Job Name: Brockwell Park, Herne Hill Job N<sup>o</sup>: IMA-08-088

## Consideration of the Design & Access Statement and Associated Documents

TITLE: - Plan 1 -  
 IMA Visibility at the End of Slip Road

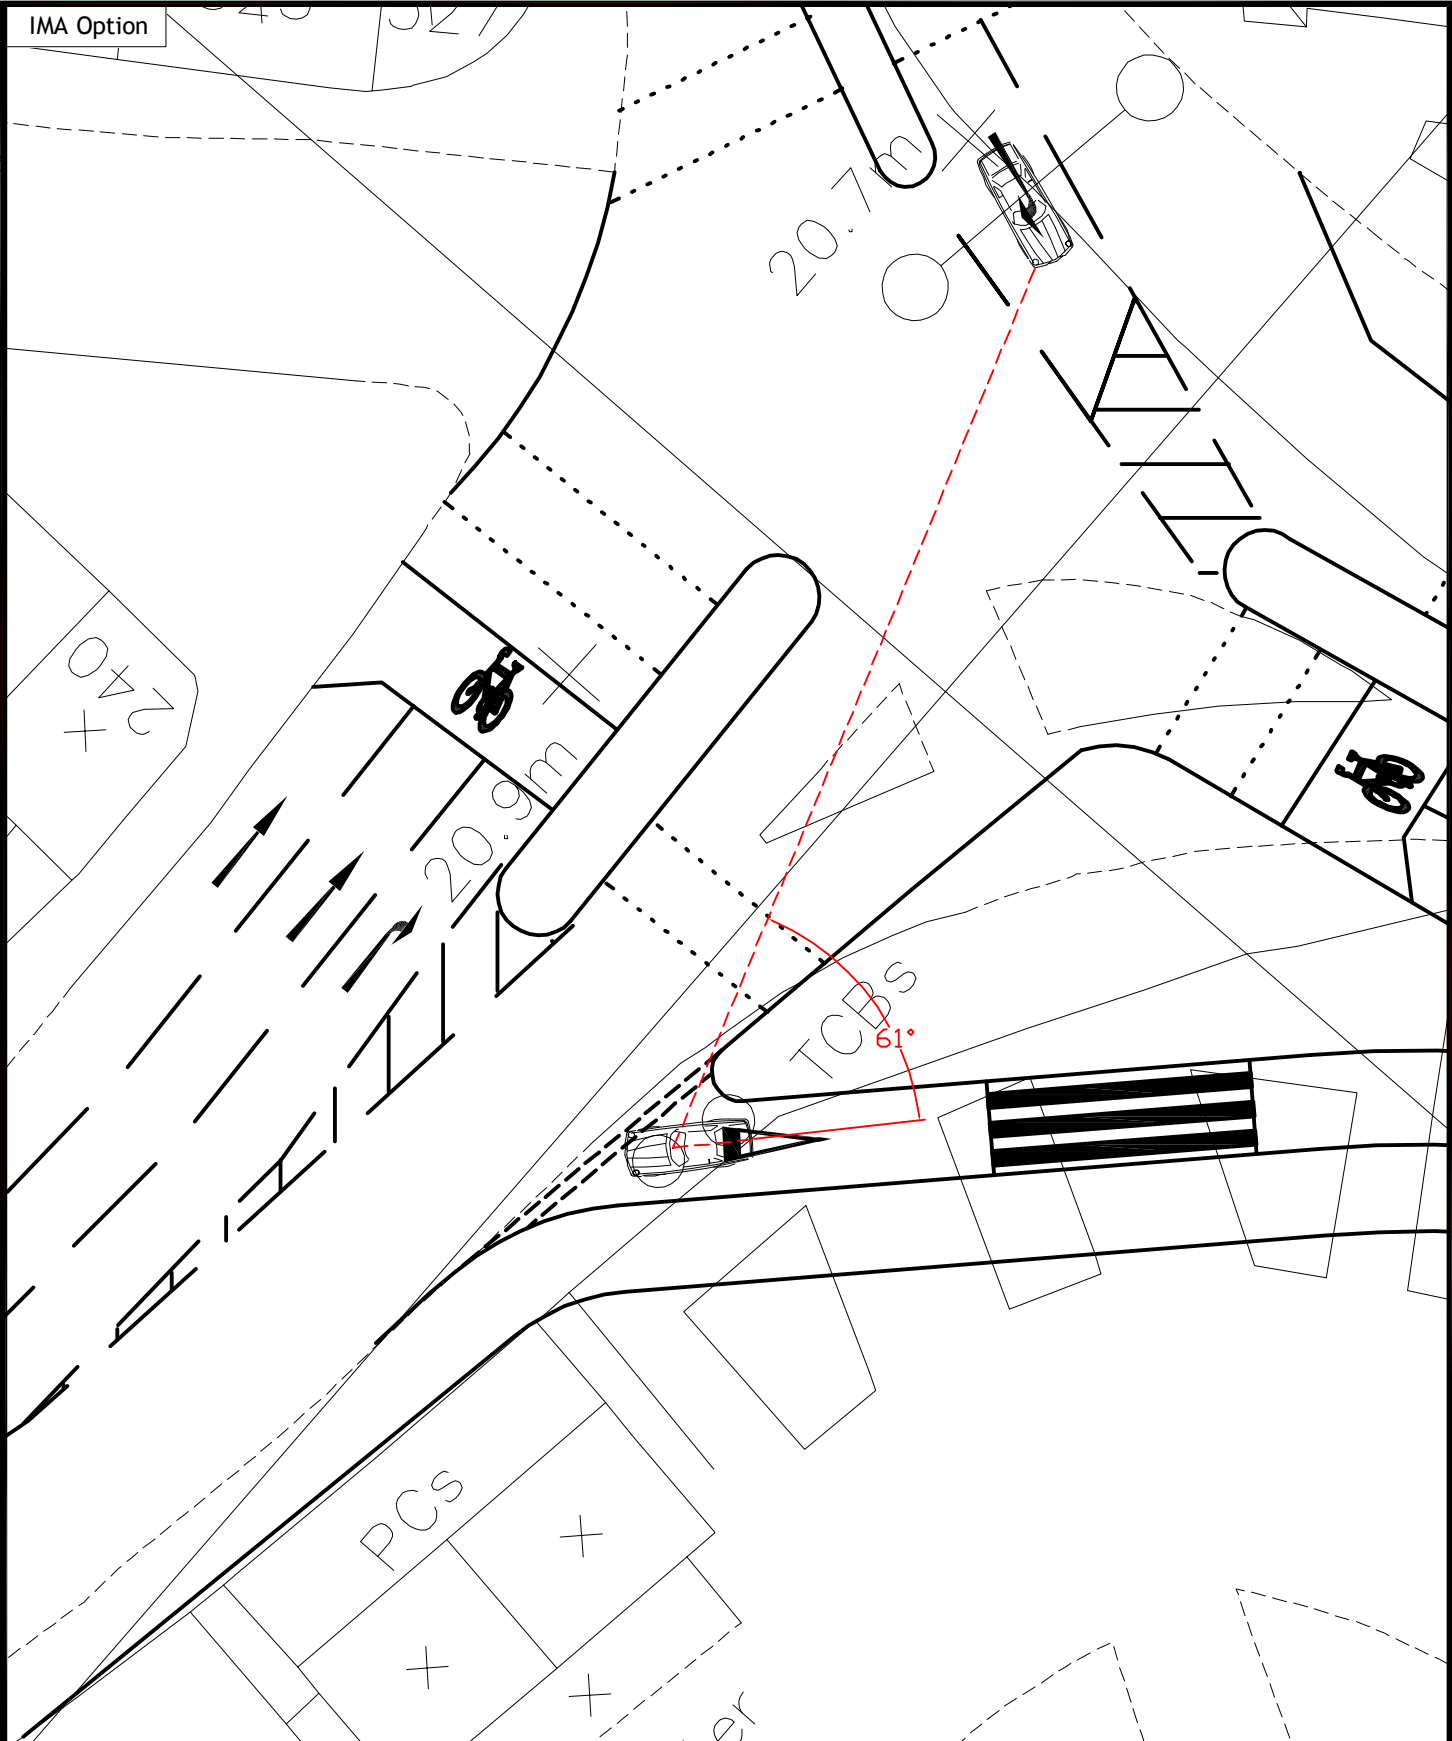
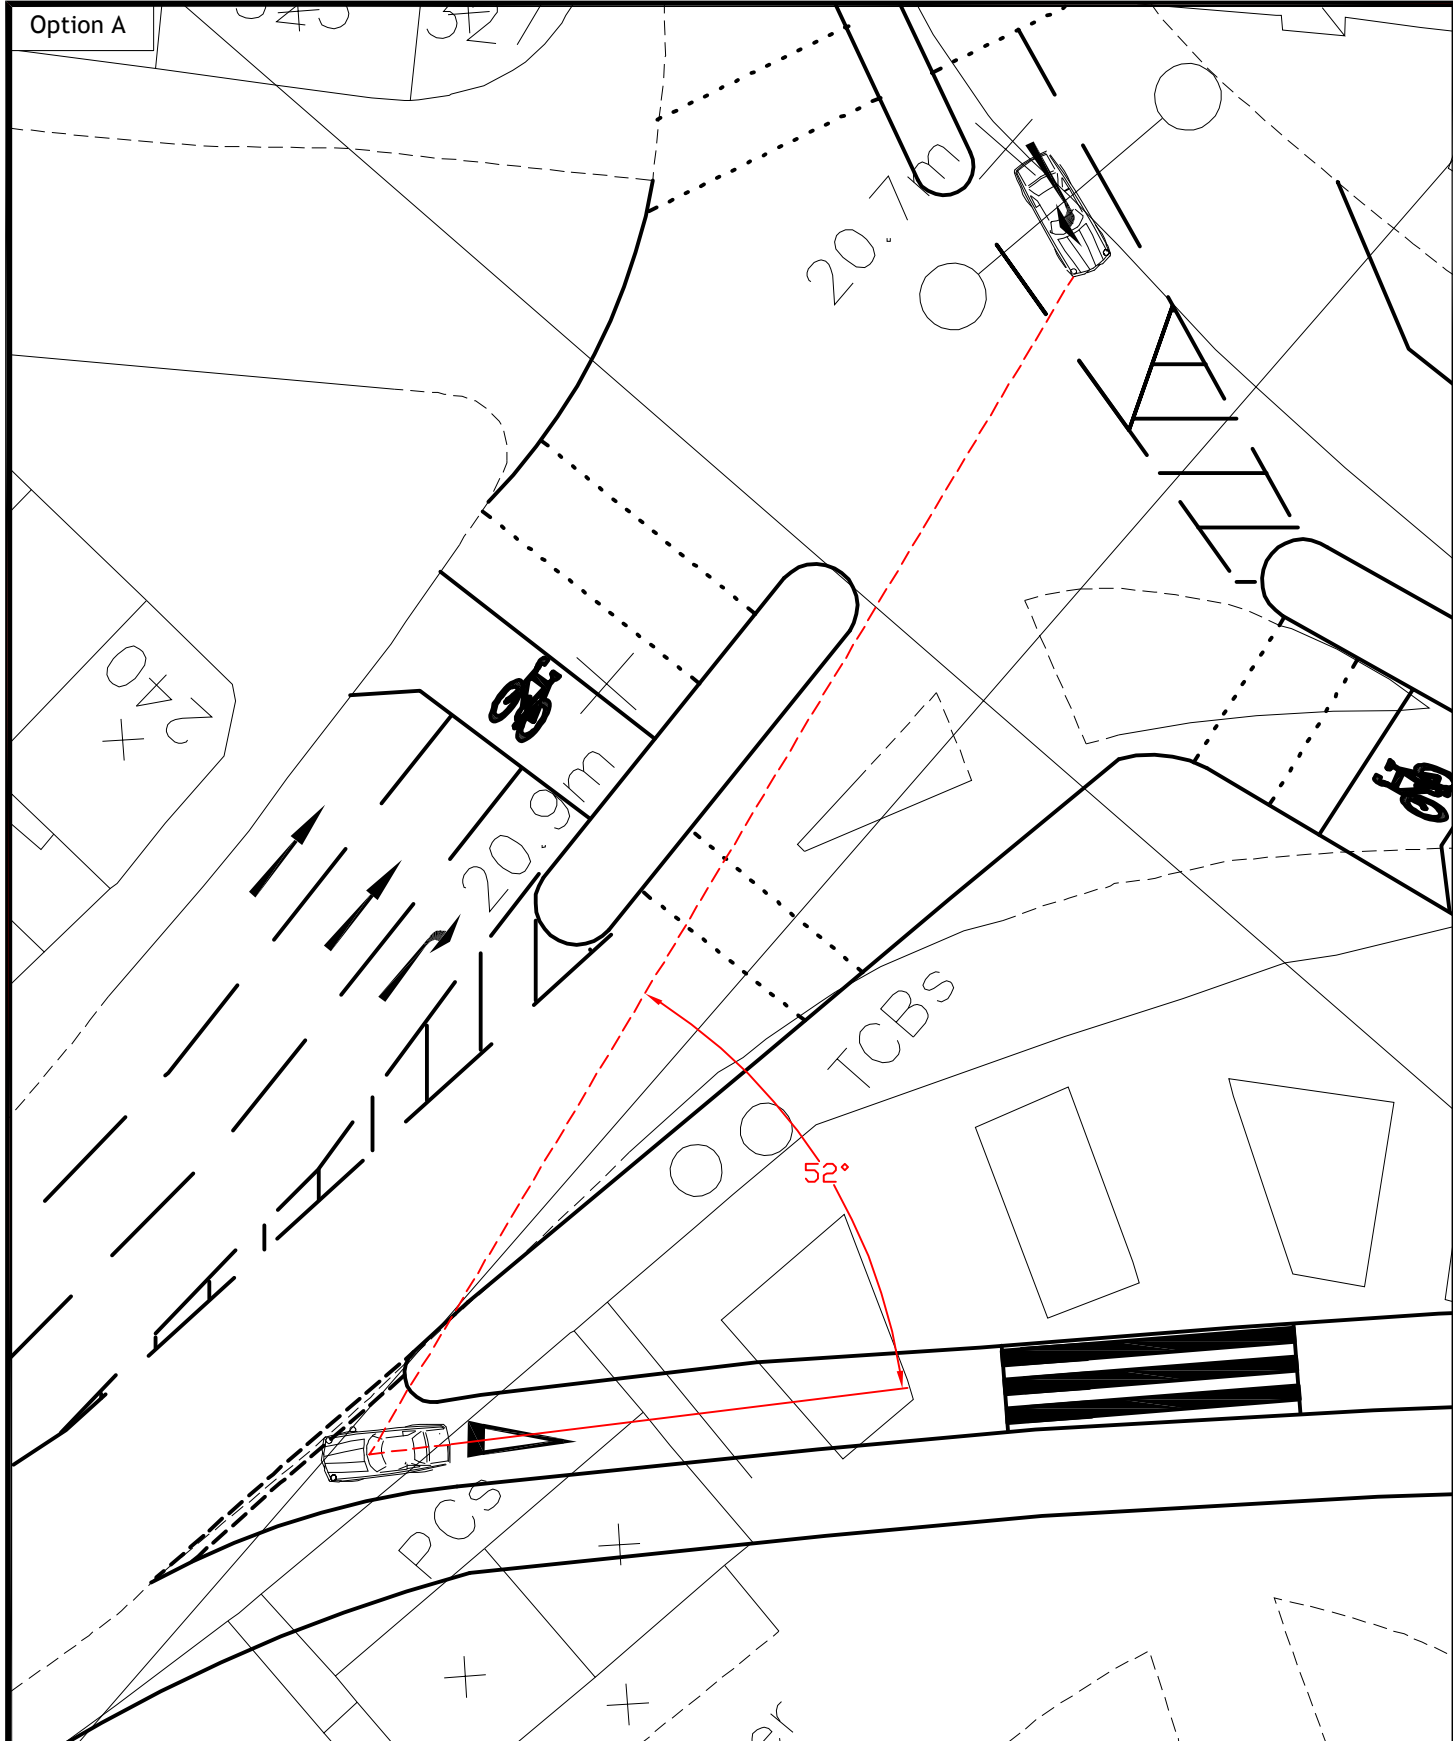
8. The ‘Transport Design Statement’ sets out a series of key considerations for the design of the scheme, and these are examined individually below.

TITLE: - Plan 2 -  
 Proposed Layout Visibility Comparisons

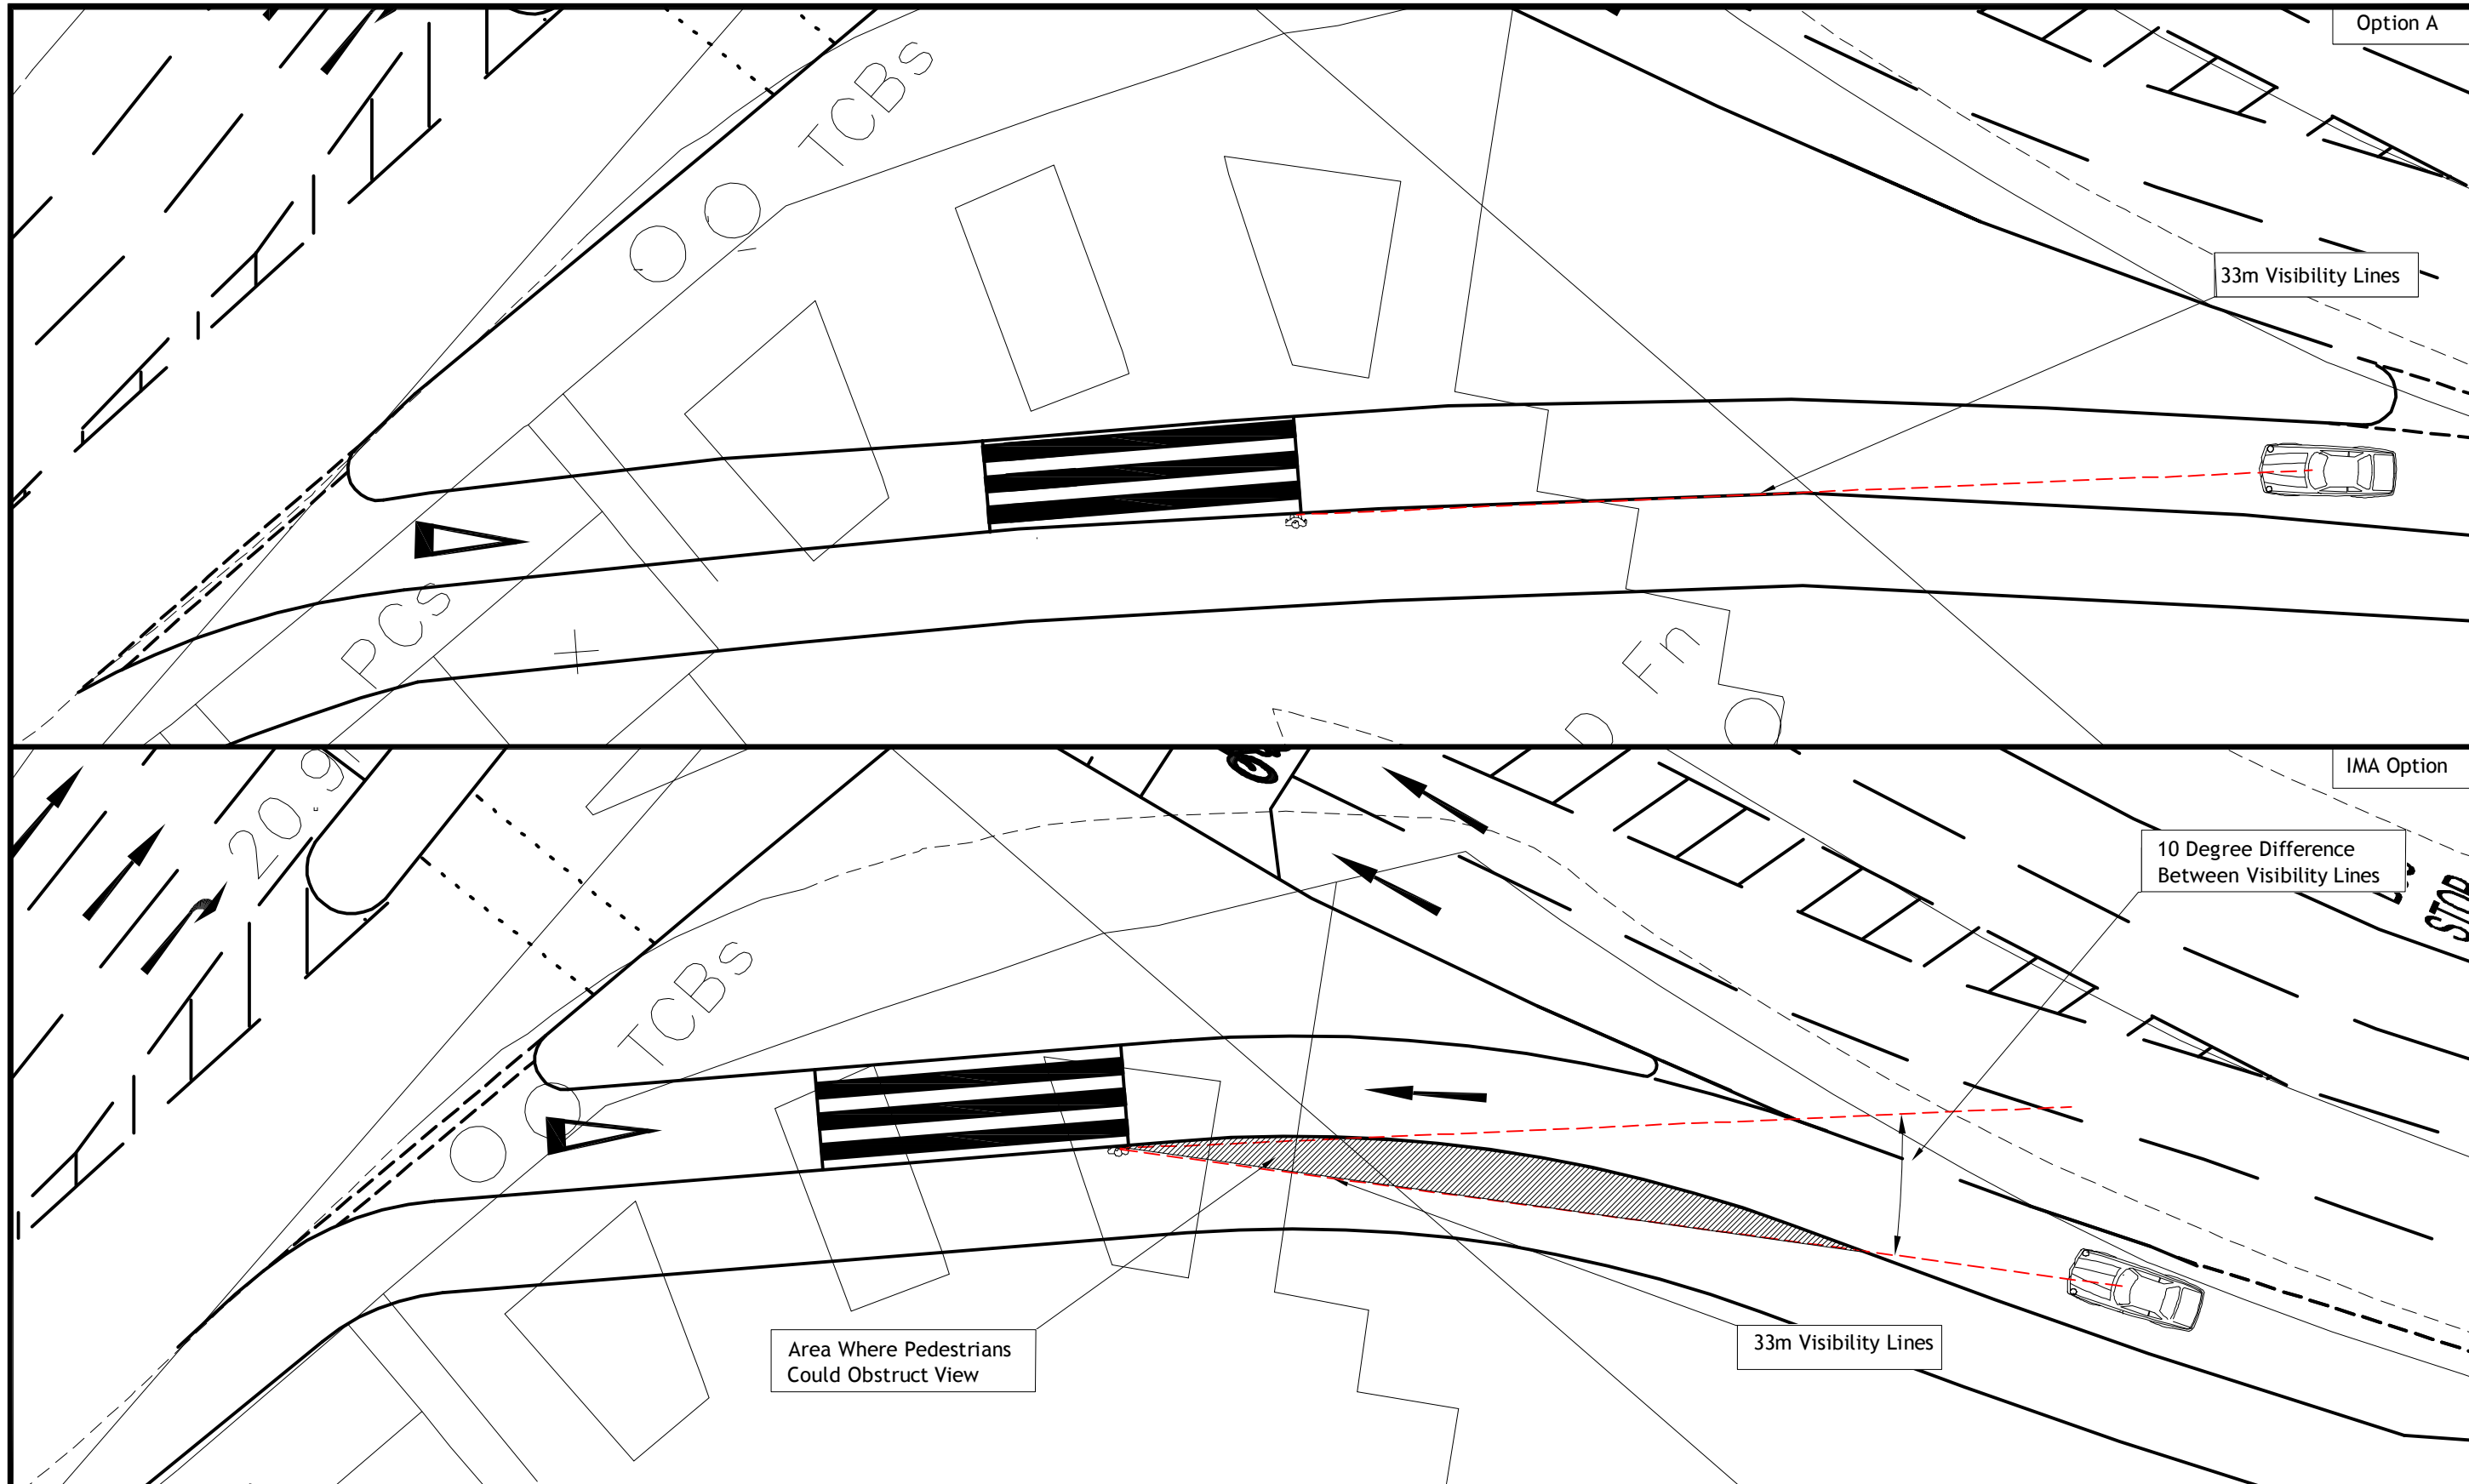
21. The IMA alternative introduces curvature into the slip road, which will minimise vehicles speeds. However, that curvature does also impact on visibility, as illustrated in Plan 2, which shows a 10m wide crossing as per the Lambeth scheme, notwithstanding the fact that a 5m crossing is likely to be adequate and more in keeping with the capacity of the connecting pedestrian facilities.

22. It is evident from Plan 2 that a pedestrian stood at a zebra crossing would have to look slightly further around to their right, but only by some 10 degrees, which is not considered significant.

23. A matter of greater significance is the shaded zone in Plan 2, which shows the line of visibility between a pedestrian at the crossing and an approaching car. Any pedestrians in the footway in the shaded zone would impact on visibility.

24. One solution to this would be to alter the alignment of the slip road to that shown in Plan 3. The inter-visibility on the approach to a zebra crossing would then remain unobstructed.
